Certificate of Appropriateness—Amended

Property	2251 N. Lake Dr. North Point South HD		
Description of work	South chimney will be tuck pointed and deteriorated bricks will be replaced. Chimney will be rebuilt to match existing and retain corbeled profile. Some bricks will be utilized to infill area at lower level of home. At the southwestern corner of the rear of the home, an area of previous brick infill will be removed and refilled with brick and mortar that matches the existing condition of the home.		
	Original Glen Gery brick has been discontinued. The Sioux City brick on the last page is an approved substitute as is the mortar sample.		
Date issued	10/8/2019 Amended & extended to expire one year from 9/9/2020	PTS ID	114596 COA masonry repairs

Detail images of coursing sample and brick to be utilized.

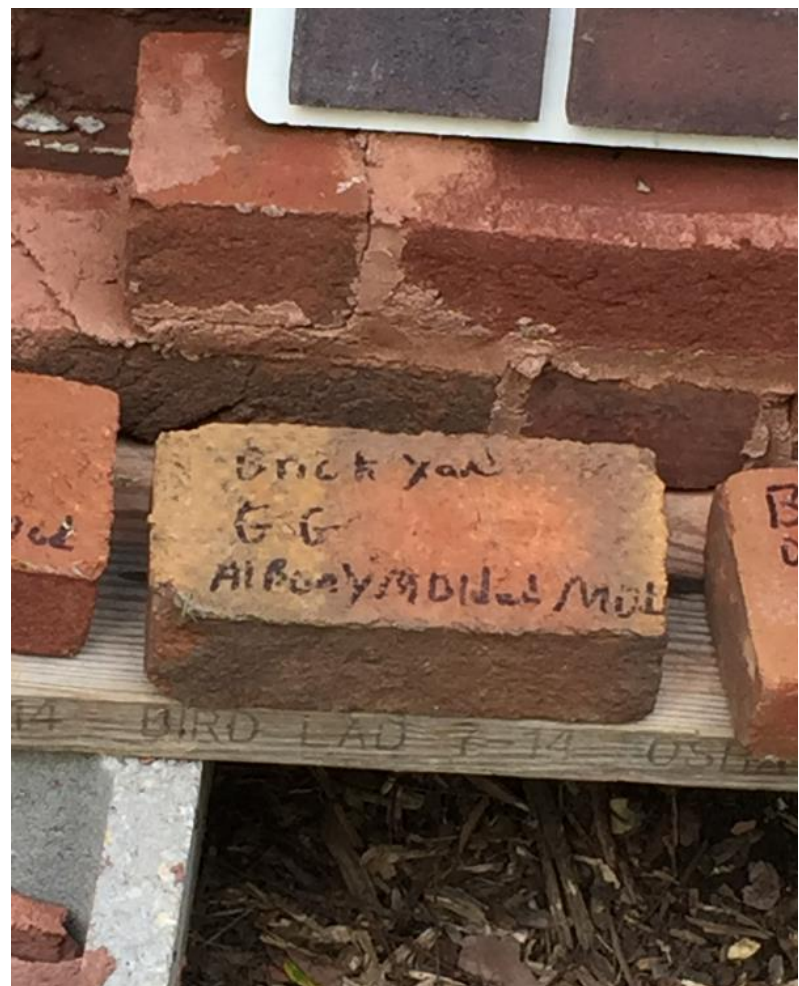
Mortar sample is approved as to color only. Joint profiles and thicknesses will match existing.

Glen Gery brick was discontinued before project could begin. Sioux City sample at right will substitute.
